GAINES CHARTER TOWNSHIP
PLANNING COMMISSION – REGULAR MEETING
Township Board Room - 8555 Kalamazoo Ave. S.E. Caledonia, MI 49316

DRAFT Agenda

7:00 p.m. – Thursday, July 25th, 2024

Planning Commission Memo

SHEET NAME
 GROUND PLAN
 WITH MODULES

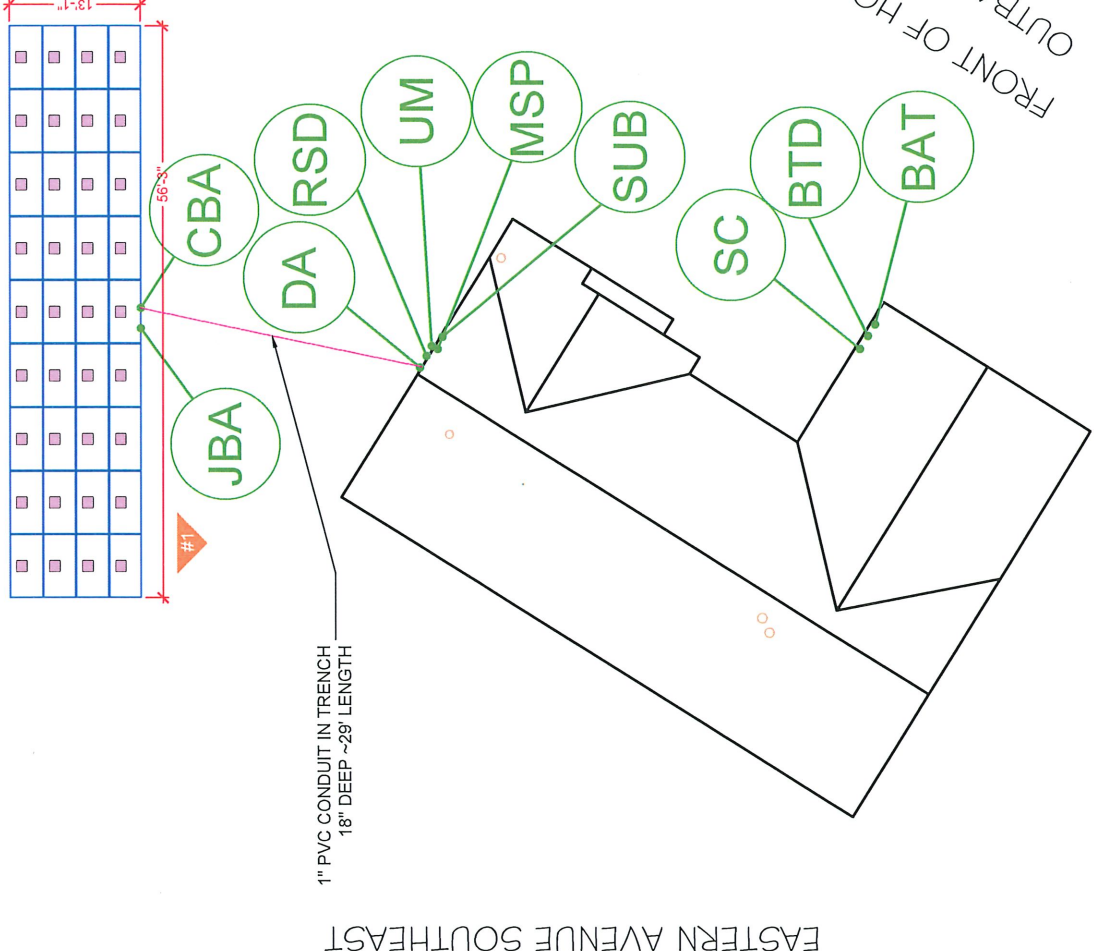
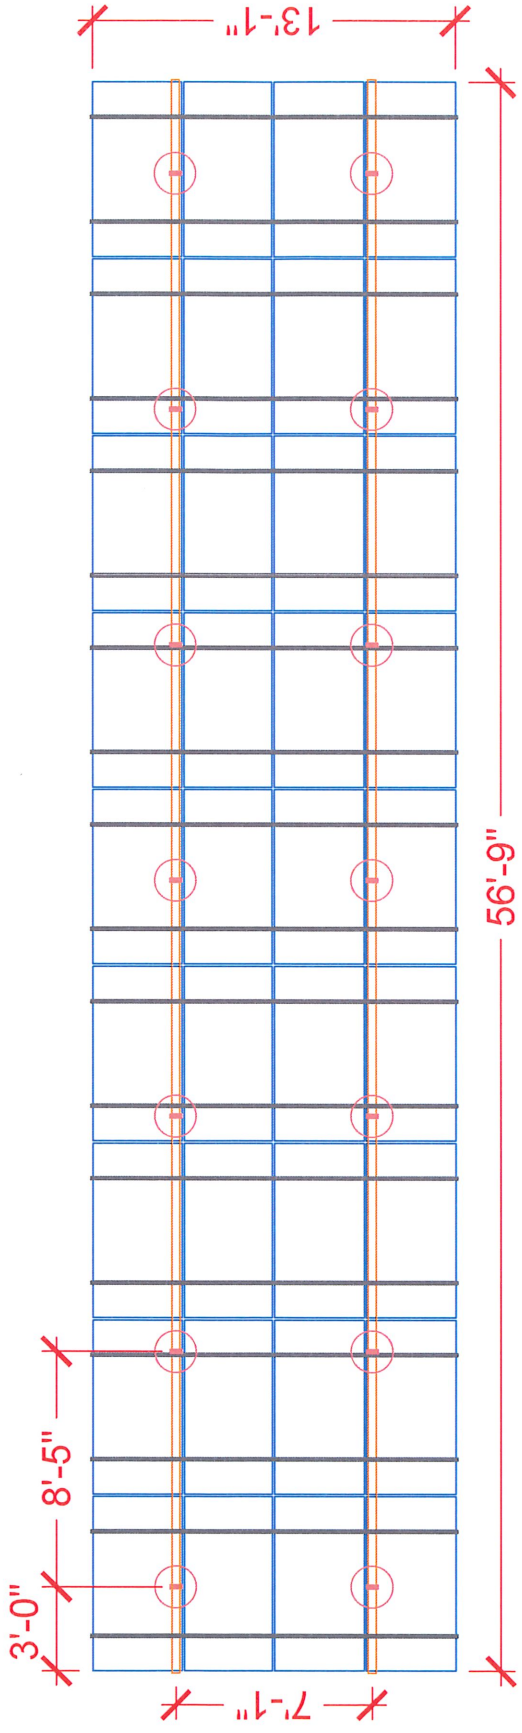
Staff recommends reconsideration of the location for the array in order to meet the requirement that it be located in the rear yard (4.18.D.1). Otherwise, staff recommends approval of the site plan for the construction of the solar array, with the following conditions;

Title: Modified to Move Driveway To East

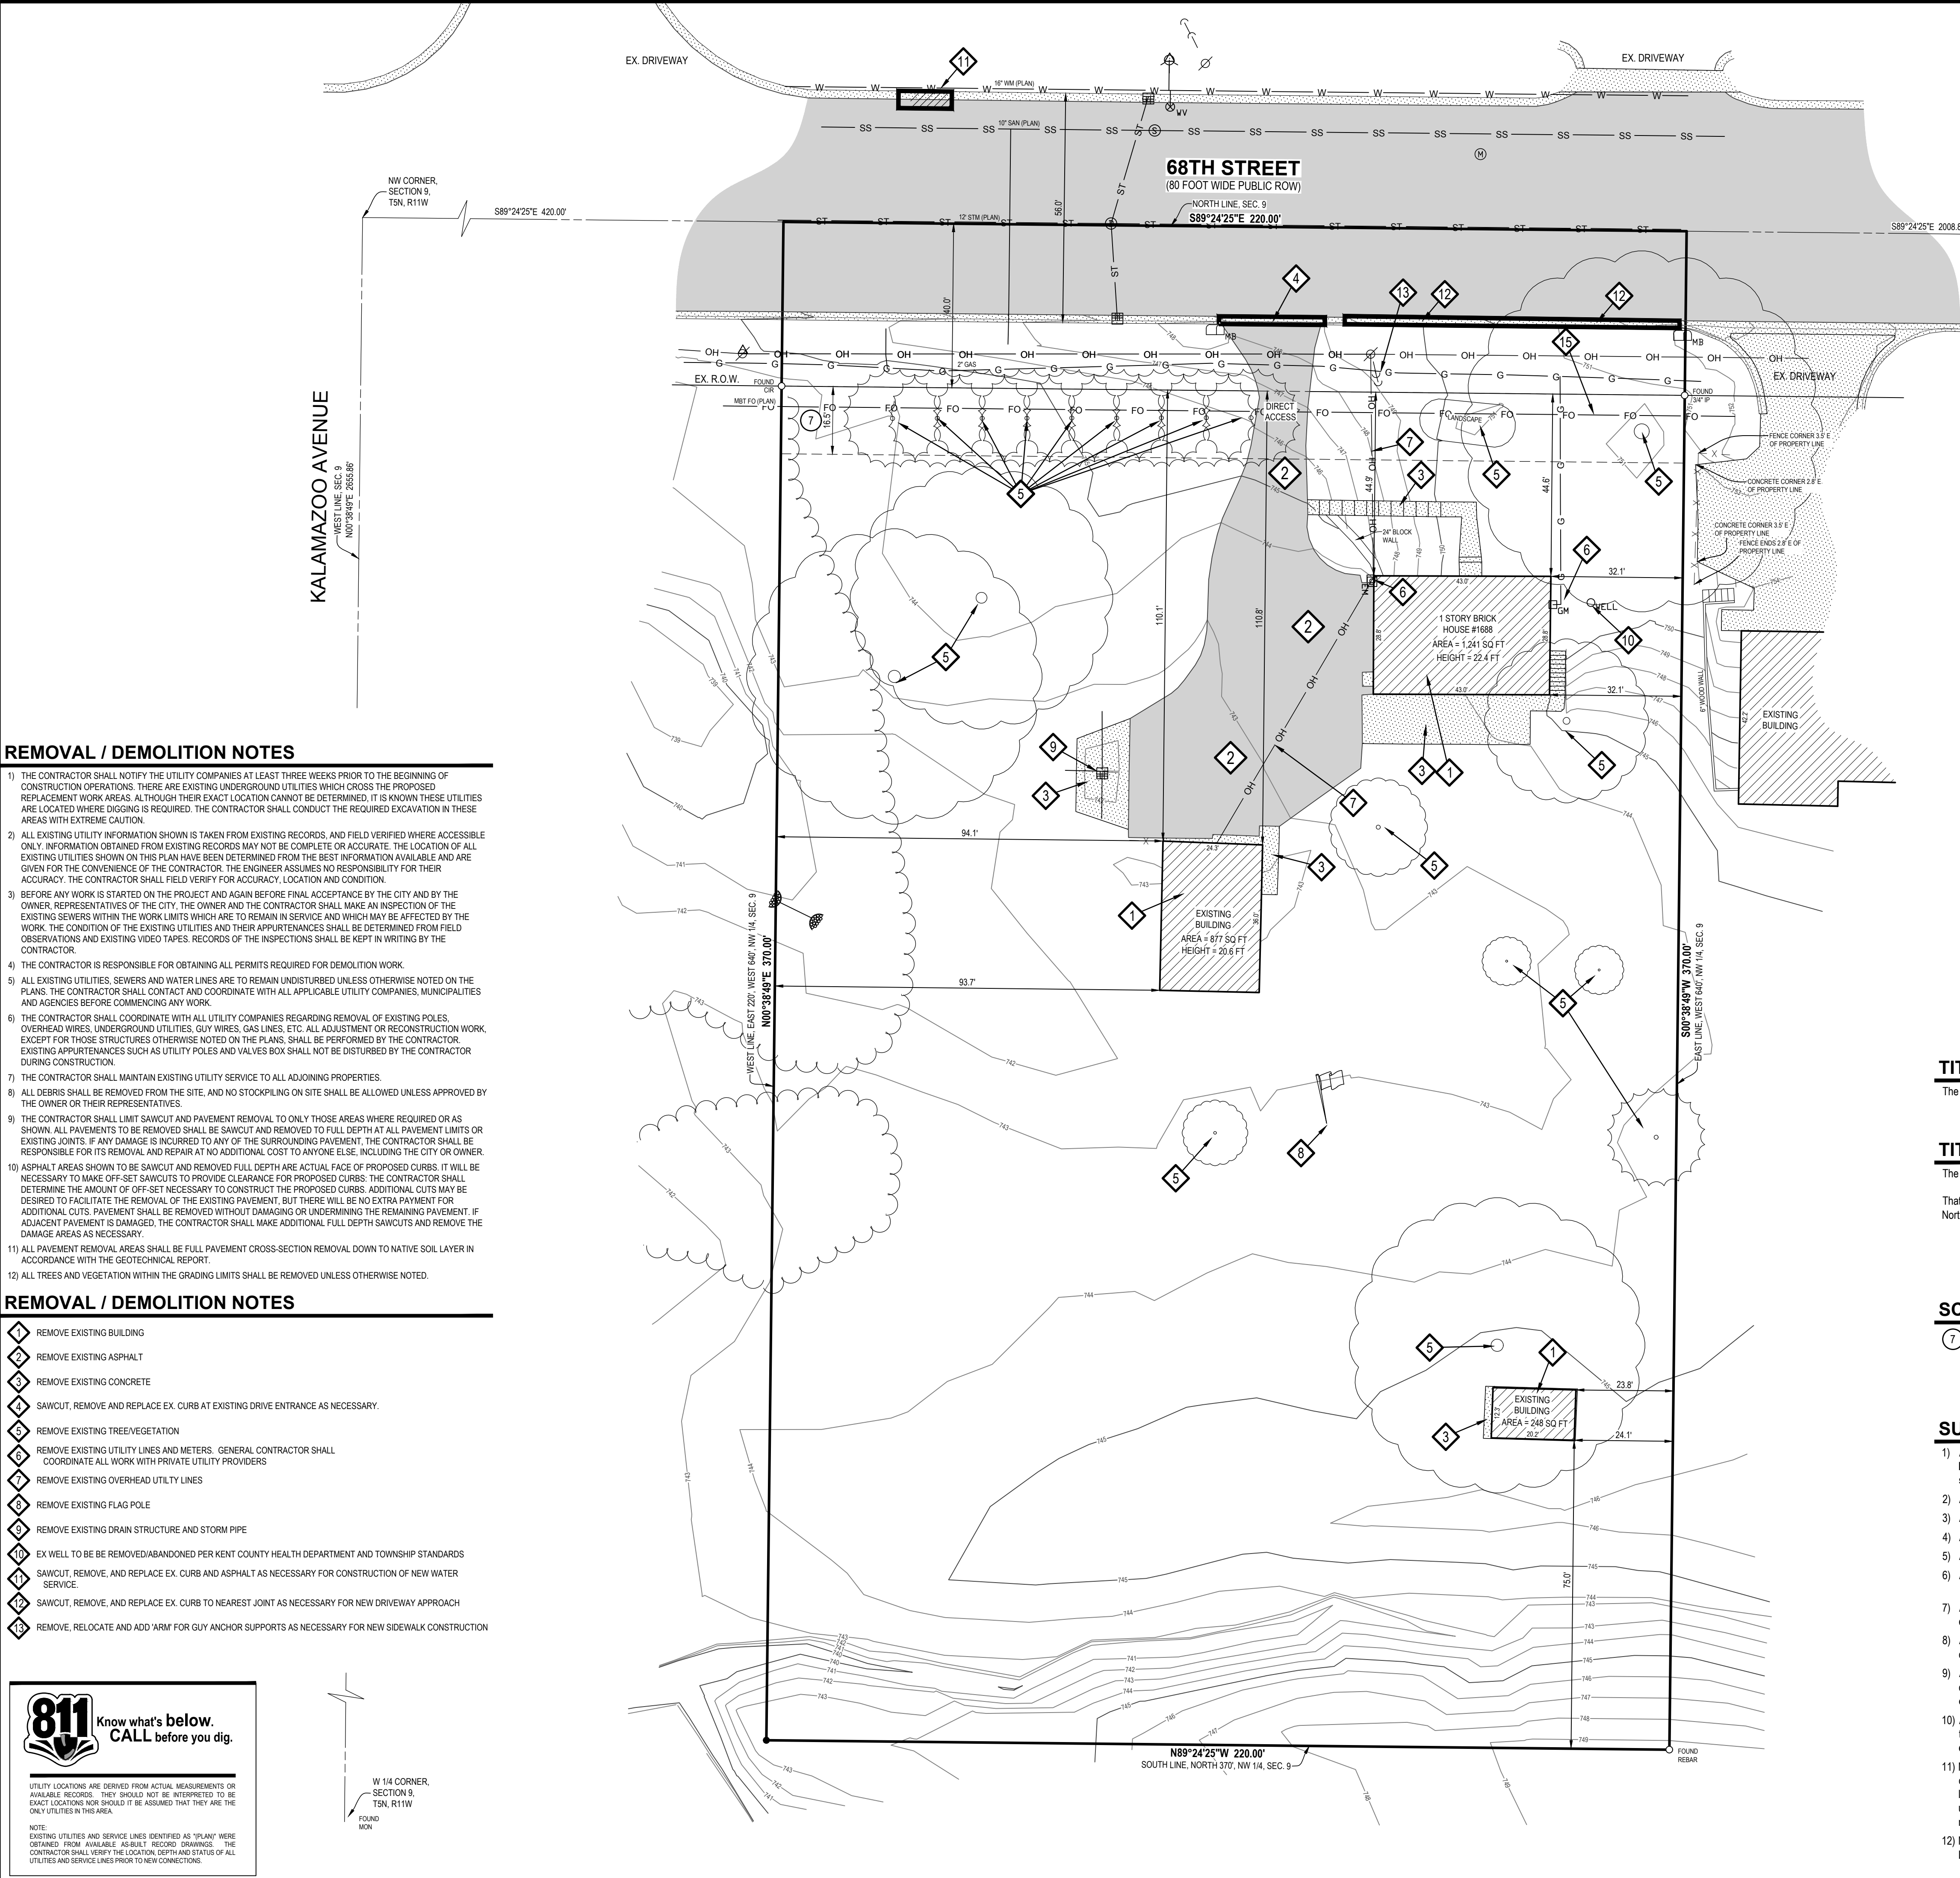
The overall feeling was that the Planning Commission wasn't quite ready to approve this project; Planner Wells inquired about tabling this agenda item, and inquired about what further information would assist the Commissioners in making a decision. Chair Giarmo and Commissioner Thomas suggested moving the driveway/ curb cut as far east as possible.

Motion:	Motion by Rober, supported by Thomas, to table this Special Use Permit/ Site Plan Review.
DISCUSSION:	Thomas expressed that she would like to see the curb cut moved as far east as possible.
AYES:	Rober, Billips, Thomas, Wiersema
NAYS:	Giarmo
ABSTAIN:	None
DECISION:	4-1

Kellenberger responded that they have looked at alternative driveway locations, however, as Witte had mentioned, it causes significant grading changes and would require a plethora of engineering issues. Kellenberger stated that they will investigate whatever the Planning Commission desires because they would like to move forward with this project, however, if the curb cut does move as far east as it can go, that will only be approximately 80-90 feet of difference and the same concerns will still remain.
